AGENDA
PLANNING AND ZONING COMMISSION MEETING
CITY OF CREVE COEUR, MISSOURI
MONDAY, JULY 17, 2017

2. Application #17-022: a Minor Site Plan Approval for a Real Estate Office Located Within a Single Family Home at 11142 Olive Boulevard

Peter Lu, Remax Select, has submitted for a site plan approval to use the existing home at 11142 Olive Boulevard as a real estate office. Section 405.270(D) of the C Single Family Residential District provides that for an existing single-family residential structure on Olive Boulevard, the Planning and Zoning Commission may approve a site development plan in accordance with the procedure provided for in Section 405.1080 to permit the conversion of the structure to an office or retail service use in accordance with the standards provided in Section 405.450(E), Commercial Uses of Single-Family Residential Structures. City Council Action is not required

Figure 2: Close-up of the rear parking area of the site plan with additional landscaping needed indicated in red.

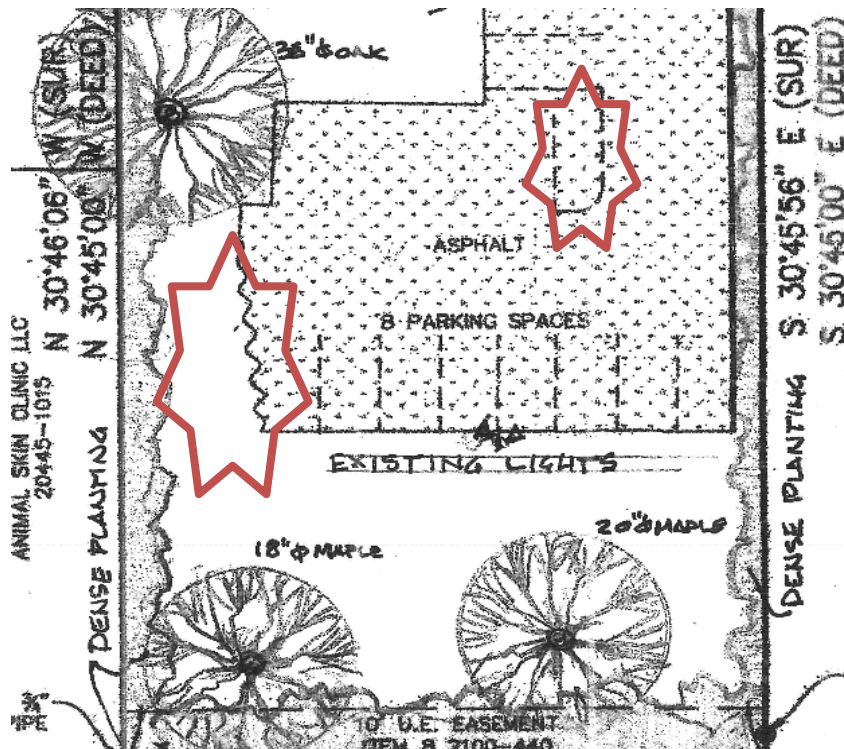
While visiting the site, the landscaping along the west property line did have breaks in the views. With the resurfacing of the parking lot, additional plantings could be added within the parking lot, as well as along the west to bring the site further into compliance with the City's Landscaping requirements of Section 405.540 Landscaping, and Section 405.810(A)(5) Design and Maintenance Standards of Off-Street Parking and Loading Regulations, which require when off-street parking or loading areas are located adjacent to a residential district or to any lot upon which there is a dwelling as a permitted use there shall be provided a continuous opaque screen to a height adequate to prevent direct light from automobile headlines to be cast upon adjacent residences. Further, Section 405.540 also requires a minimum of 10 square feet of interior landscaping for every 350 square feet of paved area. Additional landscaping to break up the parking lot could be added in the area shown below, with the resurfacing and striping of the parking lot. Staff has included a condition of approval that a landscape plan by a licensed Landscape Architect be provided for the Zoning Administrator's approval to address these requirements, as well as provide additional plantings adjacent to the building. An underground irrigation system is not required at this time, due to the pre-existing nature of the site.
